**Commission of Architectural Review  
Certificate of Appropriateness Application**

Property Address: 3301 E. Marshall St Current Zoning: UB  
Historic District: Chimborazo

## Amended Proposal for Storefront Facade Renovation

North Facade

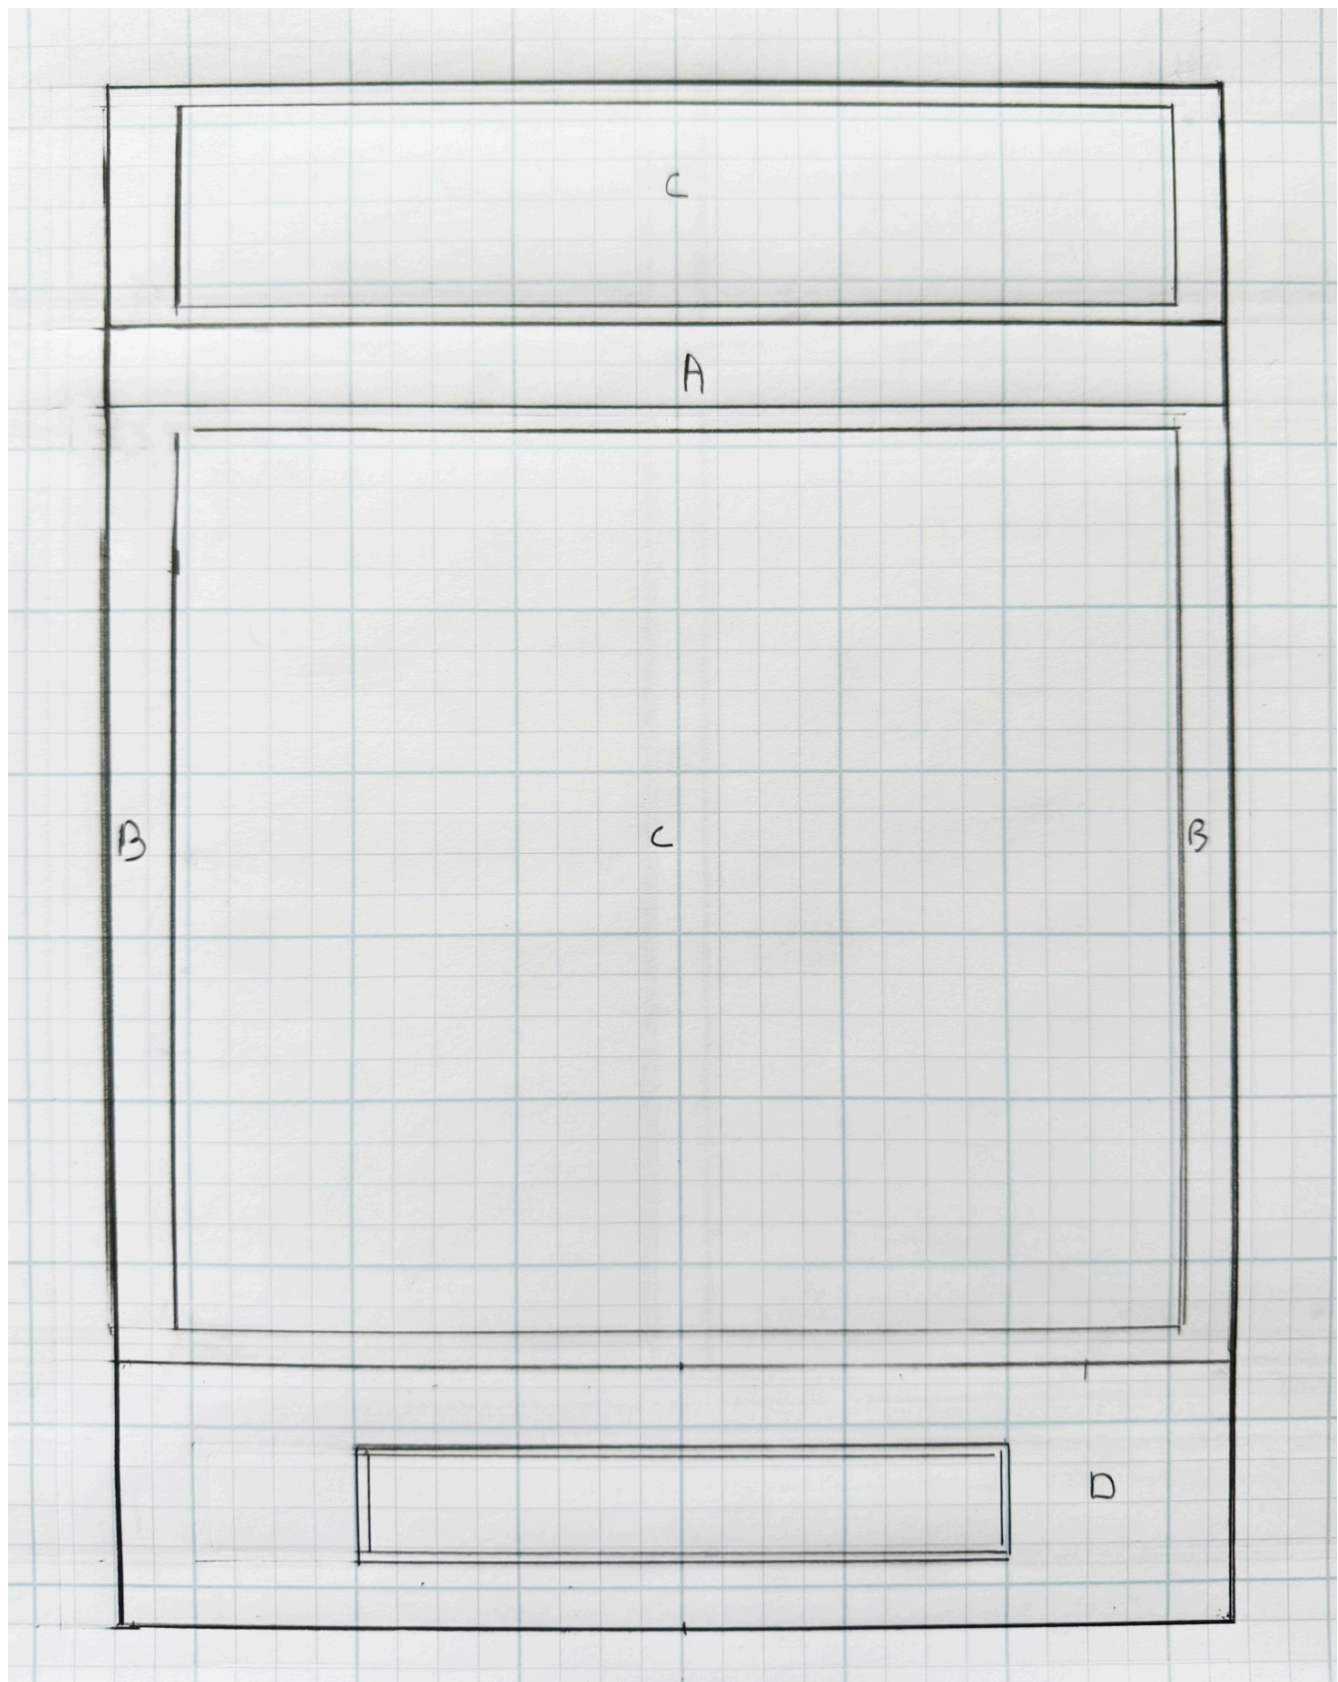
2. The current configuration has been modified over time. There are currently 8 display window panes and 5 transom panes. The 1950's historic photo shows 5 display panes and 5 transom panes. The modified plan will reduce the number of display panes from 8 to 5 and eliminate the 3 mullions that were not present in the 1950's photo. The modified plan will retain 5 transom panes as depicted in the 1950's photo.

3. The transom bar will be leveled and support posts will be added at the window corners to correct structural deficiencies. Dimensions of support framing, casing and glass trims to be determined in consultation with a structural engineer.

4. The bulkhead will be simplified. Paint colors to be determined in consultation with CAR staff.
5. The facade is currently a mix of wooden elements and glazing secured in a commercial aluminum mounting system. The current mounting system is no longer available. Contemporary aluminum storefront systems (as originally proposed) differ in dimension and proportion from historic standards. The modified plan proposes stick built framing that will be constructed on site. The design will utilize 1x material as casing to secure IGU (insulated glass units) glazing. Trim will be added to conceal the IGU spacer bars. The layout of fenestration will be amended from the current storefront configuration to better reflect the dimensions and proportions of the 1950's photo, and to harmonize the overall design. A structural engineer will be engaged to determine framing and trim dimensions, and to ensure longevity of the proposed design.

- A. Historic Transom Bar
- B. New Transom Support with field installed casing to secure glazing
- C. Insulated glass units secured with 1X trim
- D. Simplified storefront bulkhead
